REVISION R6 · 15 OCT 2026 · APPROVED BY CLIENT

Stand 15288 · Sinor Marine / Amphicos
Equipment layout proposal

EVENT	ADIPEC 2026, ADNEC
STAND	15288 · 6 × 5 m · 30 m²
TYPE	Peninsula, 3 sides open
REAR	Shared wall, Stand 15285
UNITS	cm unless noted
REVISION	R6
DATE	15 Oct 2026

Proposed top view

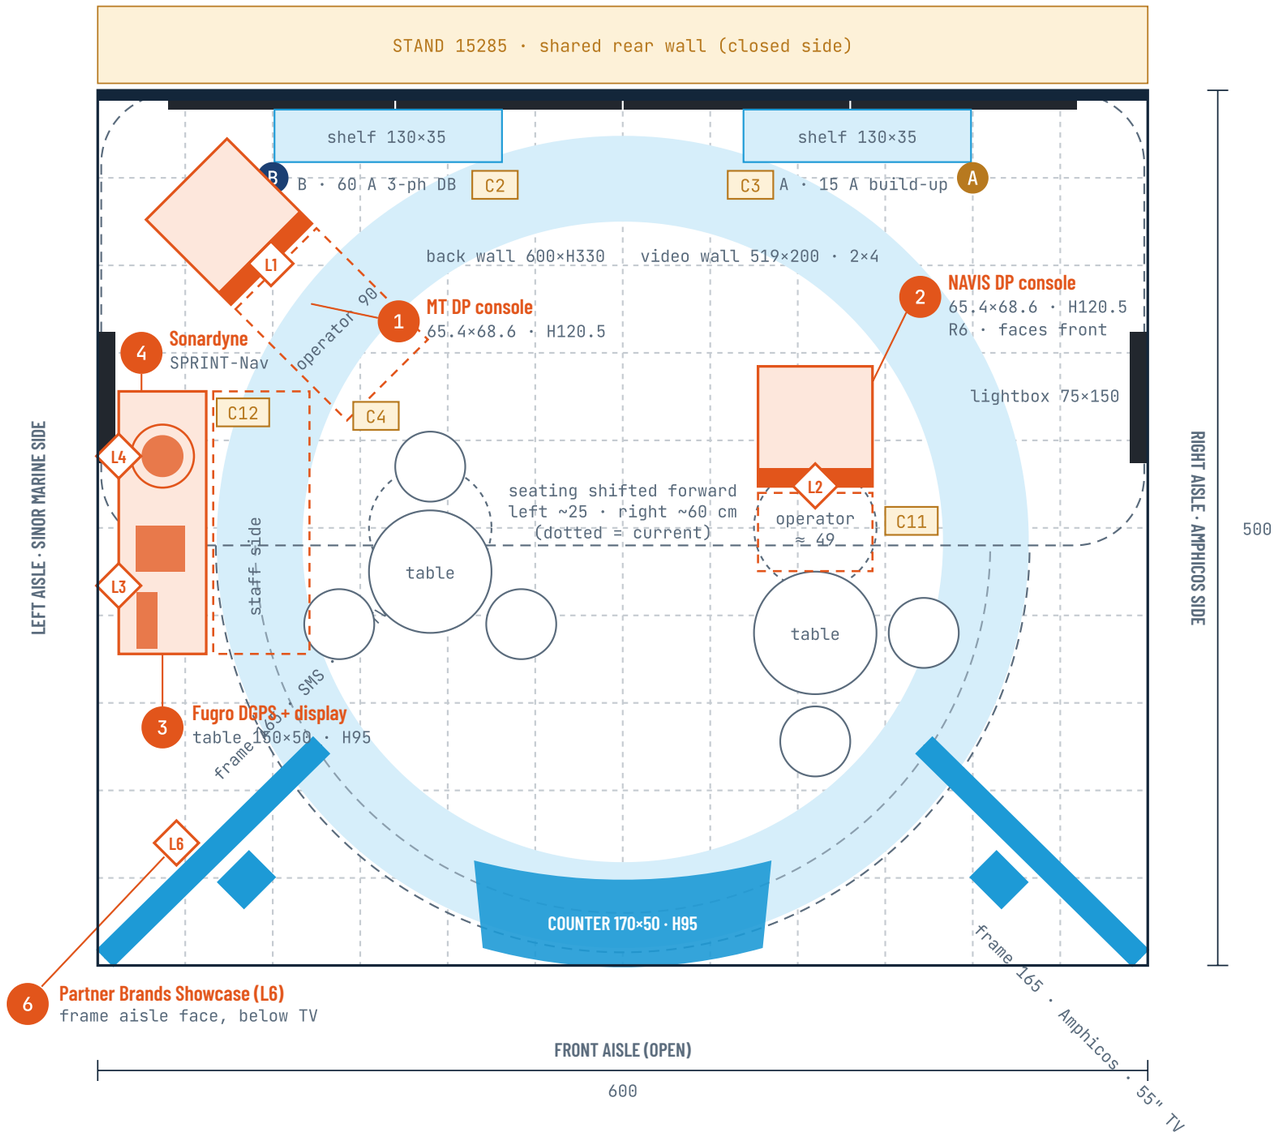
R6	15 Oct 2026	From the client's marked-up plan. SMT logo below the video wall (item 5, L5) removed; SMT now appears only in the Partner Brands Showcase. NAVIS console moved from the rear-right corner to right of centre (centre 410 cm from the left, 192 cm from the rear), square to the front aisle with the screen facing visitors; it takes the place of the right seating group's rear chair, and that group moves a further 35 cm forward with two chairs. Sonardyne table on the right edge removed; Sonardyne, in its lockable cradle, joins Fugro on one left-edge table, now 150 × 50 × 95 cm (was 100 × 50 × 95). Right rear corner and right edge left empty. Item numbers unchanged; 5 and L5 are retired.

Existing elements are drawn from the Amphicos booth drawings (scale 1:10). Seating positions and the lightbox column position are scaled from the renders and side views, so they are approximate. Logo markers sit on the face that carries the logo: L1 and L2 on the console front cabinets, L3 and L4 on the aisle-facing front of the shared left table, L6 on the left-aisle face of the Sinor Marine frame. L5 (SMT on the back wall) was removed in R6. The right rear corner and the right edge are empty from R6; power point A stays where it is.

Front elevation (from front aisle)

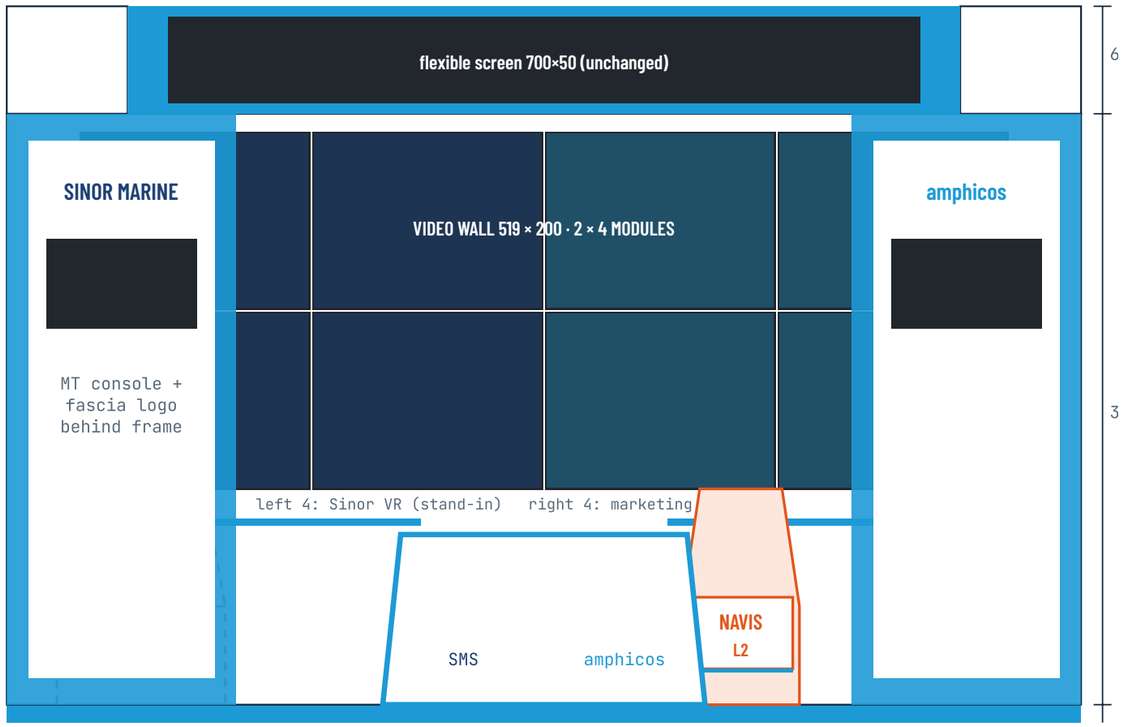
Straight on, the angled left frame hides the rear-left corner, so the MT console and its fascia logo are seen from the left aisle and on the diagonal from the front aisle. From R6 the NAVIS console (2) stands right of centre, 192 cm in front of the back wall, and faces the front aisle with its L2 fascia; the counter overlaps its left edge in this view. The rear header corners stay blank white. The video wall keeps the outer footprint of the two former screens, 120–320 cm above the platform. The SMT logo below the video wall was removed in R6. Seating is not shown.

Left elevation (from Sinor Marine side aisle)

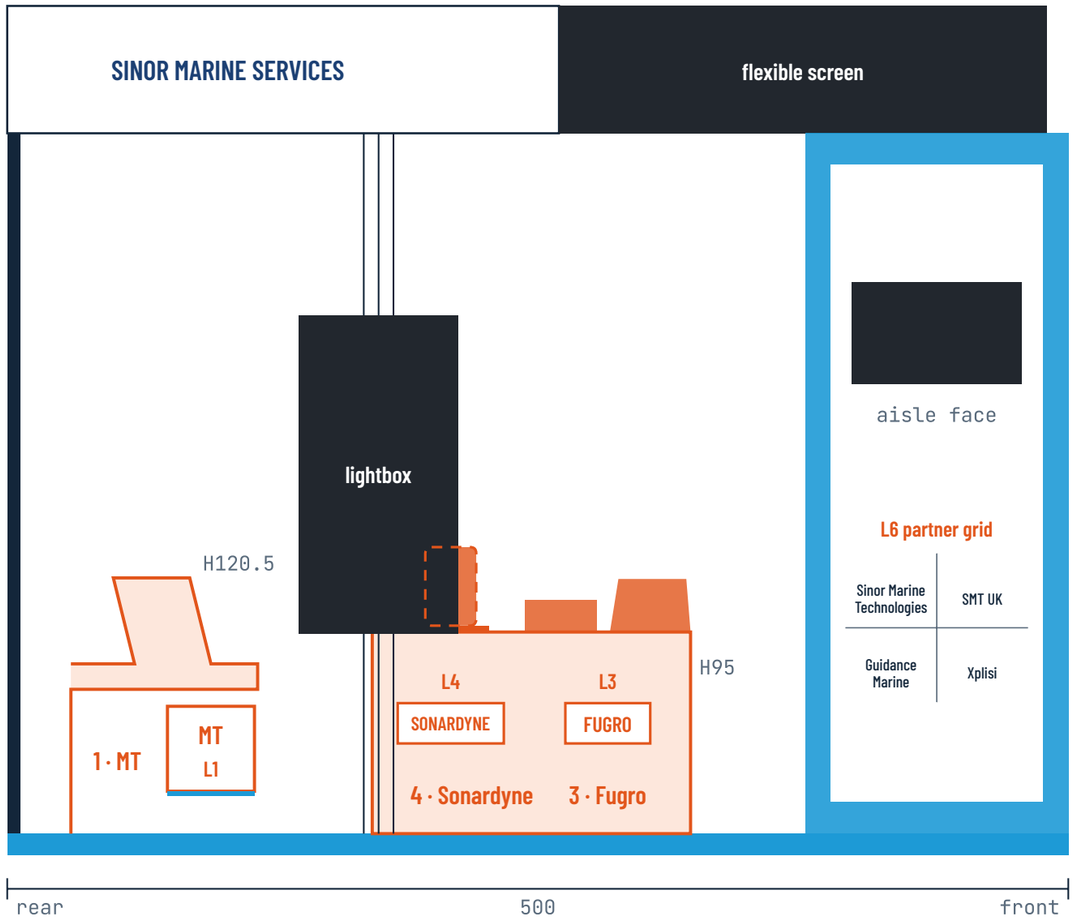
No logo is hung above the console: the MT logo is on a lit fascia across the front cabinet, 20–60 cm above the platform, and nothing rises above the console's own 120.5 cm. From R6 Sonardyne (4, logo 50 wide) and Fugro (3, logo 40 wide) share one 150 cm table, Sonardyne on the rear half and Fugro on the front half, both logos centred 52 cm above the platform. The lightbox column stands between the aisle and the rear end of the table, so the Sonardyne unit is partly behind the lightbox from this side (dashed, C12). The right edge is now empty: from the right aisle the NAVIS console (2) is seen side-on beyond the Amphicos frame, which carries no partner grid.

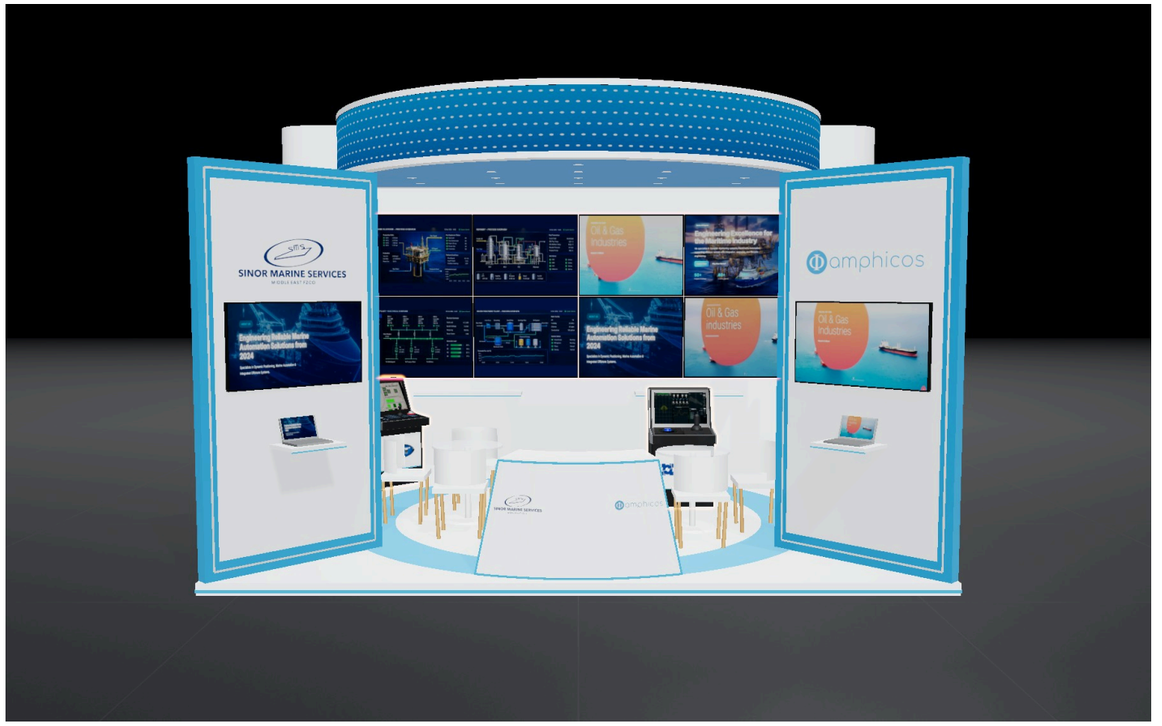
Front-right view. Video wall on the back wall, MT console in the rear-left corner, Sonardyne and Fugro on the shared left table; the NAVIS console stands right of centre behind the Amphicos frame.
